Access Compliance Report

Public Rights-of-Way

Intersection ID: 17405	Main Street: RIDGEWOOD_AV	Cross Street: WESTFIELD_RD	Location: NE
ADA ID: 242F20497725	Ramp Type: PerpDiag	Initial Pass/Fail: Fail	Overall Compliance: No
		Severity Score: 12.5

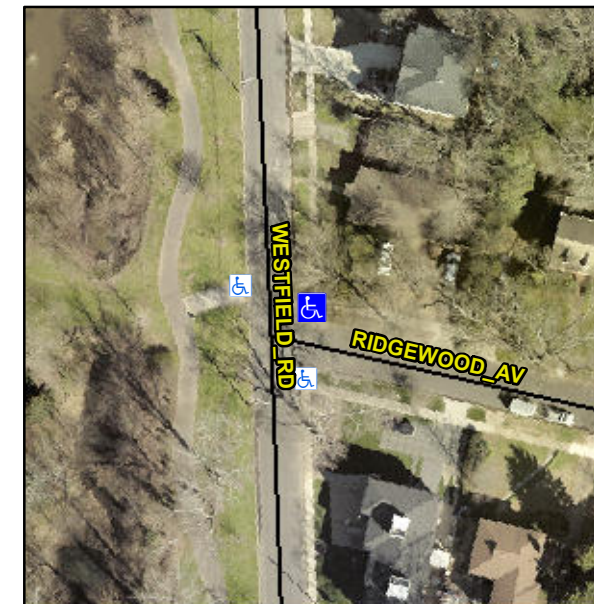
R304.5.3

Compliance	Description	Data	Compliance	Description	Data
N/A	Ramp Length (in)	93.0	Yes	Ramp Slope (%)	5.7
Yes	Ramp Width (in)	48.0	No	Ramp XSlope (%)	5.3
N/A	Flare Type LT	N/A	N/A	Flare Type RT	N/A
N/A	Flare Slope LT (%)	N/A	N/A	Flare Slope RT (%)	N/A
N/A	Flare Traversable LT?	N/A	N/A	Flare Traversable RT?	N/A
N/A	Landing Length (in)	N/A	N/A	DWS Provided?	N/A
N/A	Landing Width (in)	N/A	N/A	DWS Contrast?	N/A
N/A	Landing Slope (%)	N/A	N/A	DWS Length (in)	N/A
N/A	Landing X Slope (%)	N/A	N/A	DWS Full Width?	N/A
N/A	Landing Curb? (Y/N)	N/A	N/A	DWS Offset (in)	N/A
N/A	Shared Landing?	N/A			
N/A	Gutter Ponding?	N/A	N/A	Gutter Slope (%)	N/A
N/A	Gutter Lip Ht (in)	N/A	N/A	Gutter X Slope (%)	N/A
N/A	Painted X Walk1?	No	N/A	Painted X Walk2?	No
	X Walk 1 Direction	To NW		X Walk 2 Direction	To S
N/A	X Walk 1 Width (in)	N/A	N/A	X Walk 2 Width (in)	N/A
	X Walk 1 Slope (%)	0.3		X Walk 2 Slope (%)	3.1
	X Walk 1 X Slope (%)	1.1		X Walk 2 X Slope (%)	1.2

Remove & Replace Curb Ramp With Two New Directional Ramps or Equivalent.
